## Accessibility Survey

### City of Downey Cole Street - Milta Avenue To Cul-de-sac

Date of Inspection  
5/3/2017

Prepared By  
**Disability Access Consultants**  
(800) 743-7067

**Driveway East Of Downey Avenue @ 33.930933893414, -118.139006495476**

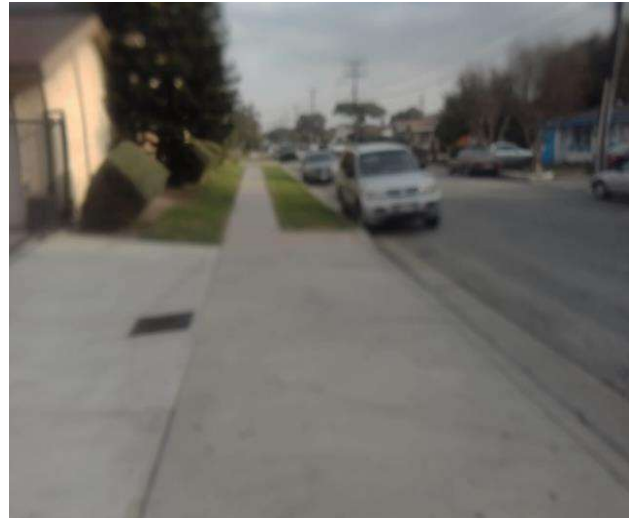
There are no detectable warnings where the pedestrian route crosses vehicular traffic.

**On-Site Finding** Not Found

Provide detectable warnings.

#### Driveway East Of Downey Avenue @ 33.930933893414, -118.139006495476

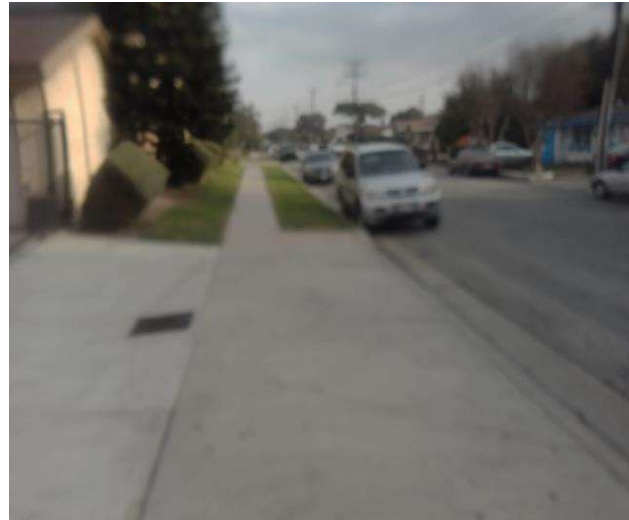
Cross slope at vehicular traffic is not compliant.

**On-Site Finding** 2.30 percent

Repave the surface to provide a compliant cross slope.

Recommendation Up to 2.08 percent

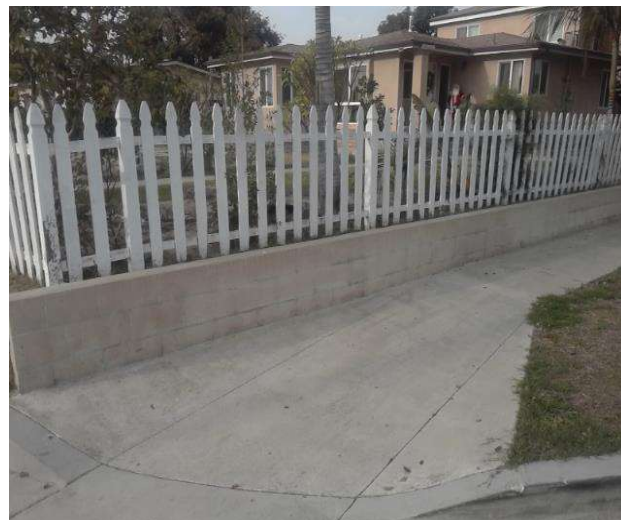
The curb ramp does not provide a detectable warning surface which includes truncated domes.

**On-Site Finding** Not Found

Provide compliant detectable warnings to surface.

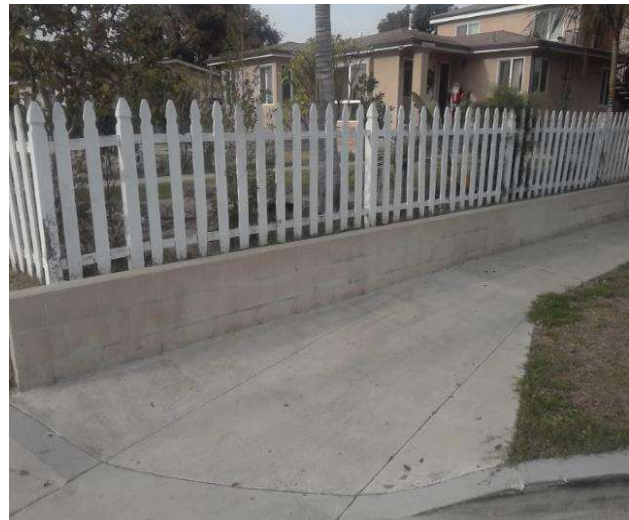
The slope of the curb ramp side flare is greater than allowed.

**On-Site Finding** 24.20 percent

Provide curb ramp side flares with a compliant slope.

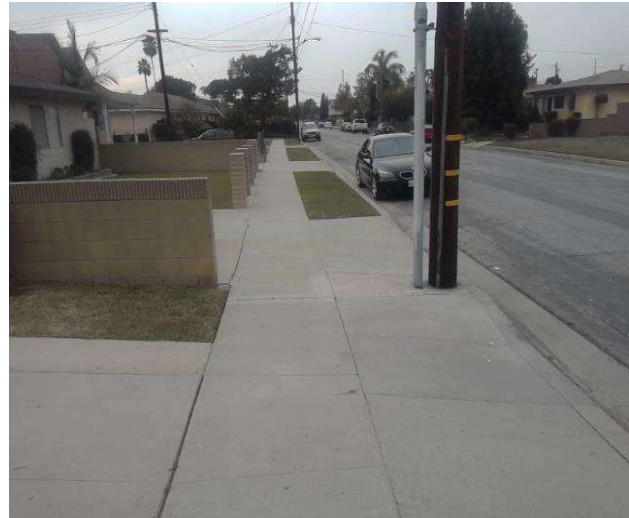
There are no detectable warnings where the pedestrian route crosses vehicular traffic.

**On-Site Finding** Not Found

Provide detectable warnings.

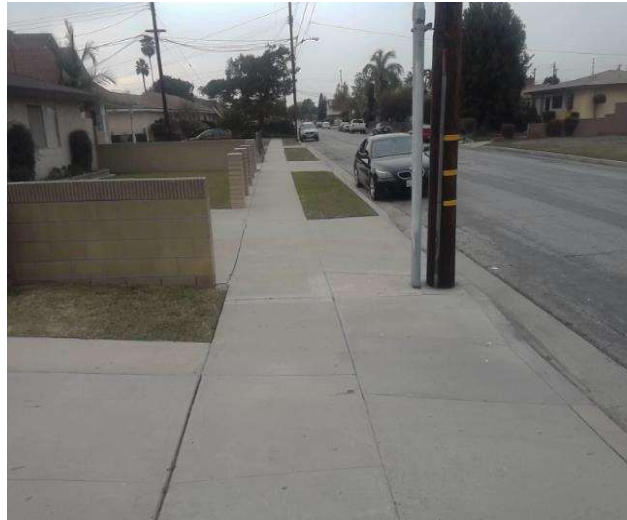
Cross slope at vehicular traffic is not compliant.

**On-Site Finding** 2.50 percent

Repave the surface to provide a compliant cross slope.
